HORSHAM DISTRICT COUNCIL CONSULTATION

TO:	Horsham District Council – Planning Dept
LOCATION:	RM Area 11 (Moathouse) Moathouse Farm Rusper Road Horsham
DESCRIPTION:	Application for approval of Reserved Matters (layout, scale, appearance, means of internal access and landscaping) pursuant to Condition 5 of Outline Planning Permission reference DC/16/1677 for RM Area 11 comprising demolition of existing garage and outbuilding and provision of 11 residential (C3) units, including single storey side extension to existing dwelling and conversion into 2 residential units and car and cycle parking, drainage, internal roads, landscaping and associated infrastructure.
REFERENCE:	DC/26/1323
RECOMMENDATION:	Advice more info
SUMMARY OF COMMENTS & RECOMMENDATION:	
Please note that these comments are based on a desk-based review of the submitted Arboricultural Impact Assessment, Arboricultural Method Statement and Tree Protection Plan. Whilst I am familiar with the wider North Horsham development, no site visit has been undertaken as part of this consultation response. The proposal seeks to retain the majority of existing trees, with only two low-quality Category C specimens (T251a and T251b) id

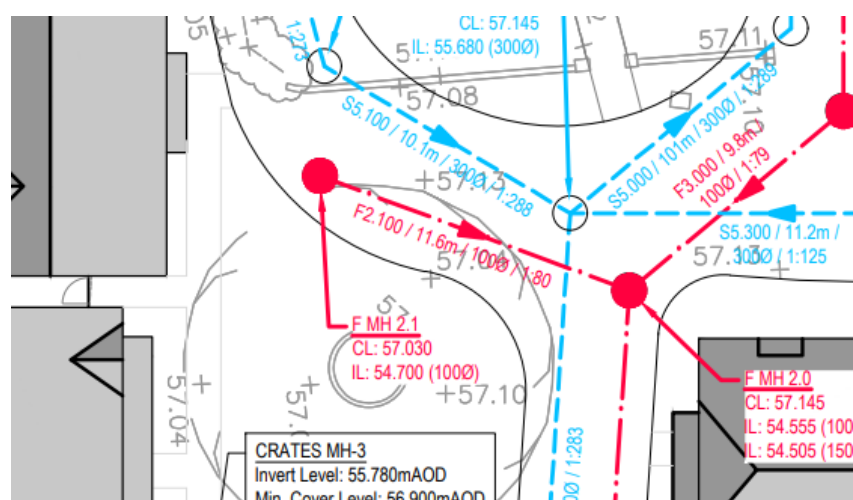
The relationship between Plot 11 and retained T256 Oak does not represent a sustainable long-term relationship. The tree's RPA extends across a substantial proportion of the rear garden, increasing the potential for indirect impacts arising from future landscaping, domestic structures and general garden use. In addition, the tree's size and proximity are likely to result in shading and give rise to foreseeable pressure for pruning works.

The tree survey advises T256 as being in only fair physiological condition, with canopy decline, deadwood and upper crown dieback noted, and the photographs provided within the submission appear to support these observations. This further reinforces concerns regarding the suitability of the relationship between the proposed dwelling and retained tree, as future occupiers are likely to have concerns regarding the tree's condition and ongoing management requirements.
